TO: **Building 532 (also referenced as 9532) Structural Repairs Bid Specification**
SUBJECT: RFP NO. 071646

ADDENDUM NUMBER # 02

Technical Addendum

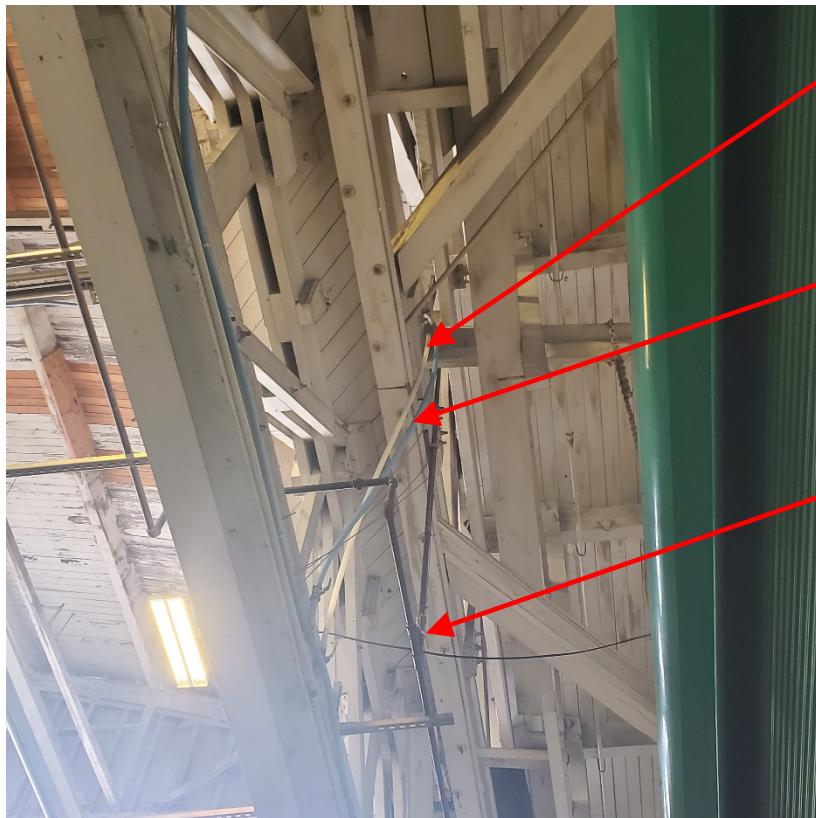
Question 5: There appears to be an air line at GL C & 14-15 that will need to be relocated for the new W18. Are there any other known or anticipated plumbing, electrical, fire alarm, etc. that are anticipated to be relocated for steel or truss installations?

Response 5: **Please refer to Addendum 2 items below; photos of utility conflicts are provided with the requisite contractor work responsibilities**

Temporarily disconnect airline to allow install of structural beam. Reroute tubing around new beam and reconnect. Test line prior to reactivating (white tubing).

Temporarily disconnect argon tubing to allow install of structural beam. Reroute tubing around new beam and reconnect. Test line prior to reactivating (blue tubing).

Shut-off gas at added valve (RE Photo 2 below. Disconnect gas piping at joints as required to install new structural members. Reroute piping around new members.

Shut-off gas and cut in new shut-off valve into gas line. Test and certify line after valve installation

Temporarily remove existing low voltage wiring as required to install new members (conductors serve PA system seen in Photo 2). Reconnect and test PA system after structural members have been installed

Resupport gas-fired radiant tube with new all 3/8" stainless steel all-thread extended from roof structure (two supports). Remove slotted channel framing support after radiant heater has been supported with the all-thread

PHASING & PHOTO REFERENCE PLAN

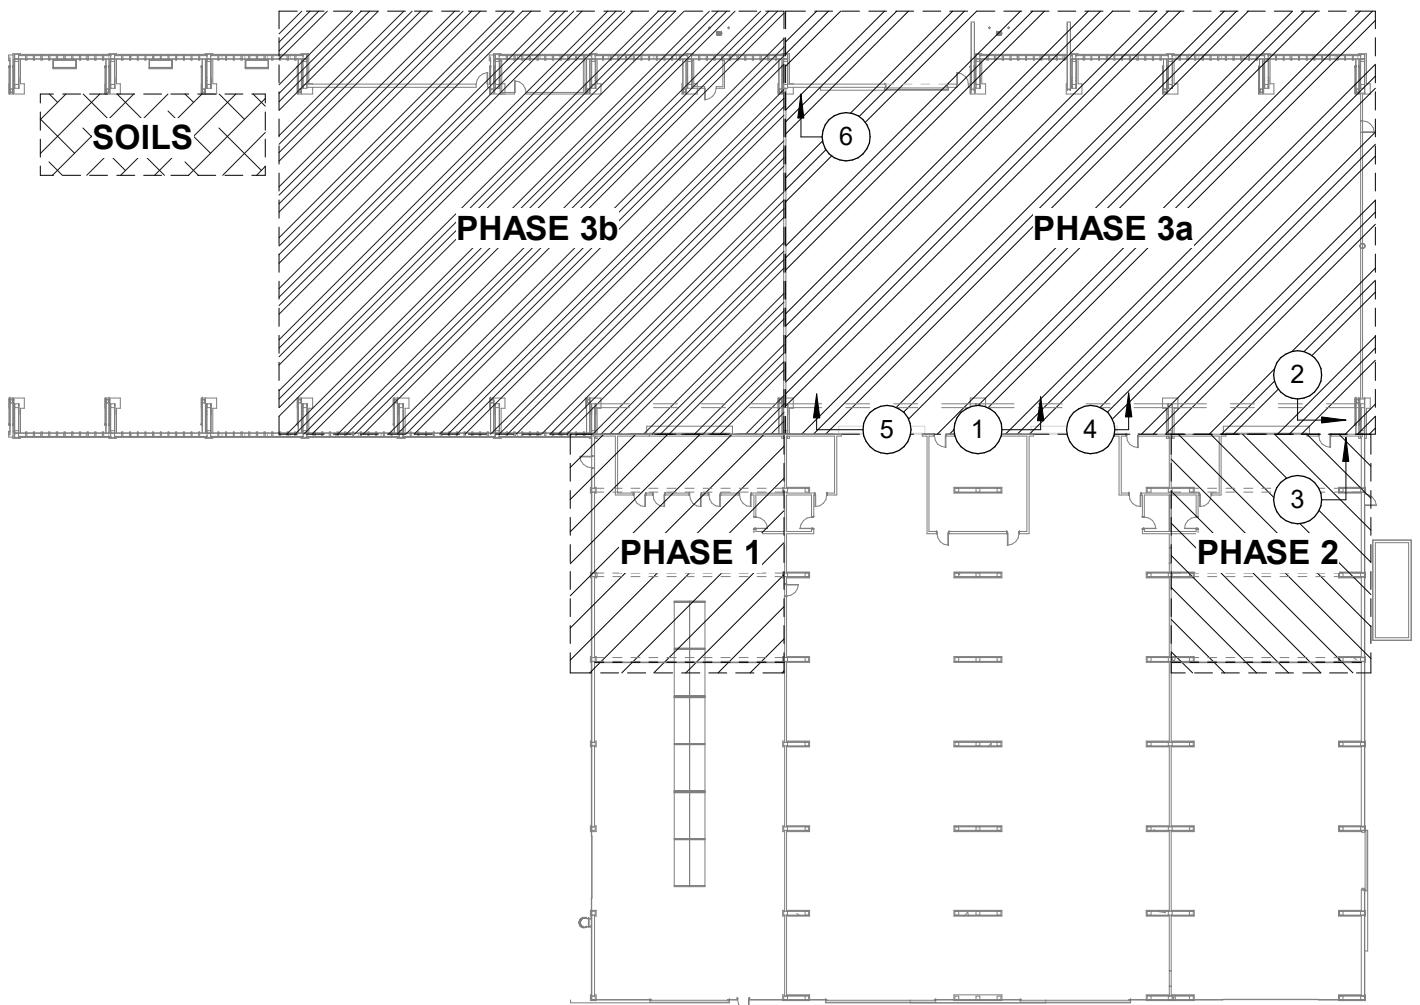
Question 3: For disposal of onsite soils, is the owner covering soils testing for disposal or should contractor assume the material can be disposed of at normal disposal locations or LRI?

Response 3: **Contractor shall refer to section 01 35 43.19 for stockpiling and testing requirements. Stockpiled soils can be stored at the covered area of the West bay along the North wall, refer to attached SK-1.0 for location.**

STOCKPILED SOILS LOCATION: EXISTING SOILS CAN BE STOCKPILED IN THE COVERED AREA OF THE WEST BAY ALONG THE NORTHERN WALL.
